TECHNICAL EVALUATION REPORT

REVIEW OF LICENSEES' RESOLUTION OF OUTSTANDING ISSUES
FROM NRC EQUIPMENT ENVIRONMENTAL QUALIFICATION
SAFETY EVALUATION REPORTS (F-11 and B-60)

NIAGARA MOHAWK POWER CORPORATION
NINE MILE POINT UNIT 1

NRC DOCKET NO. 50-220

Figure A-1. LOCA Containment Temperature with Core Spray
Stretch Power (Licensee Figure 4-12A) [14]

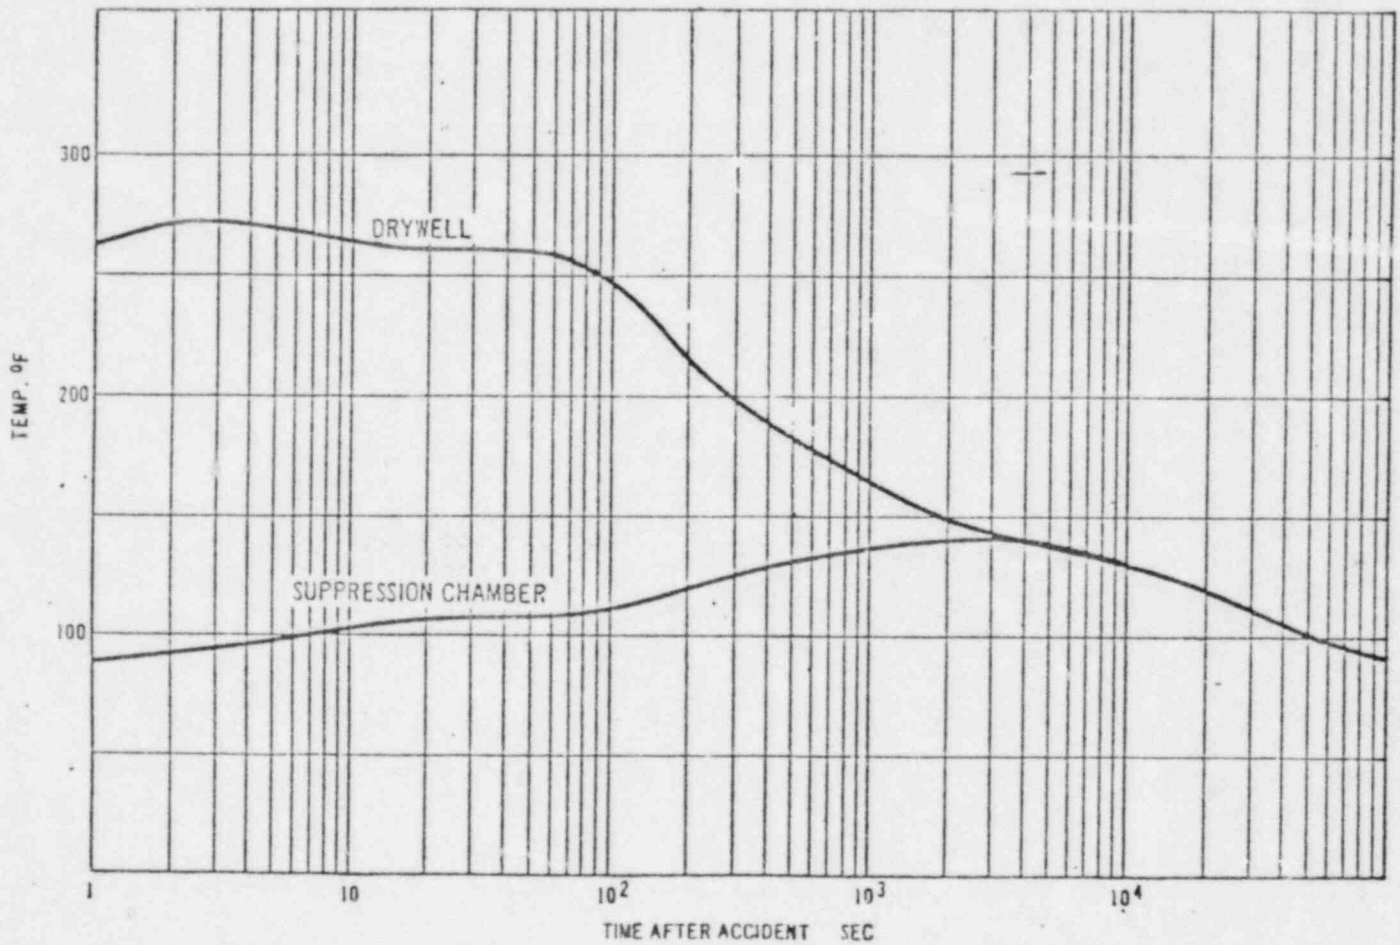
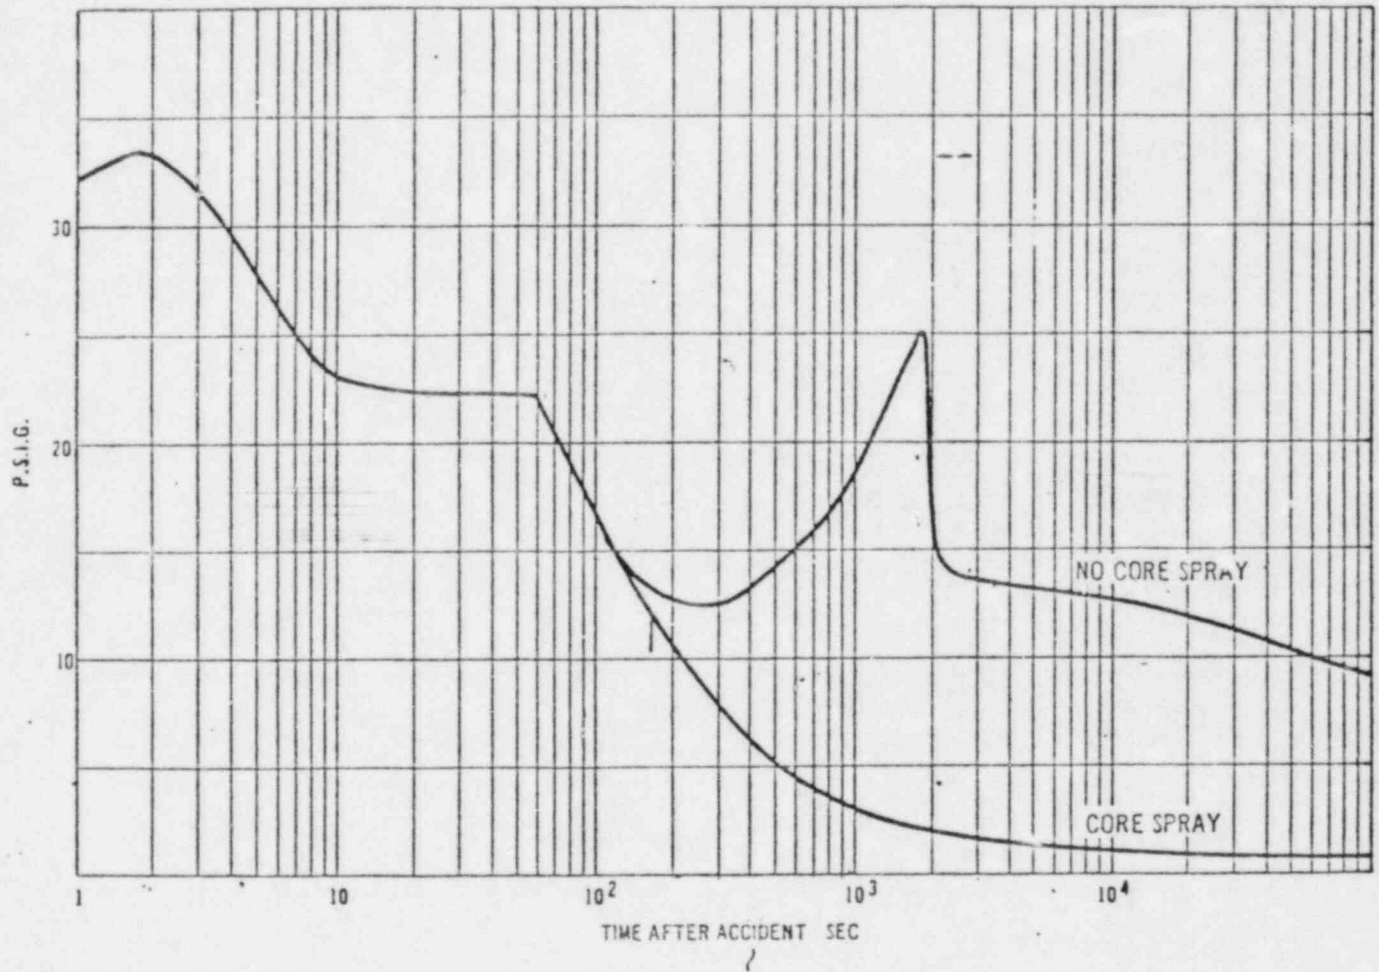
analysis may be used in lieu of 340°F for 6 hours. The Licensee has provided plant-specific temperature and pressure profiles for a LOCA event based on FSAR analysis. The Licensee has deleted the limiting pressure/temperature versus time profiles (Figures A-3, A-4, and A-5) to envelope steam line break conditions inside containment (see Licensee response below and Section 4.3.2.2 of this report); therefore, it is assumed that the LOCA profile represents the worst-case bounding accident condition.

In lieu of providing the analysis, NMPC has revised the limiting containment temperature/pressure profiles to those provided in the FSAR for recirculation line break, with 20°F added as margin to account for the possibility of local superheat. The FSAR curves were previously provided in the November 3, 1980 submittal, and are summarized in Table 4-1 and shown in Figures 4-12A and 4-12B of this report.
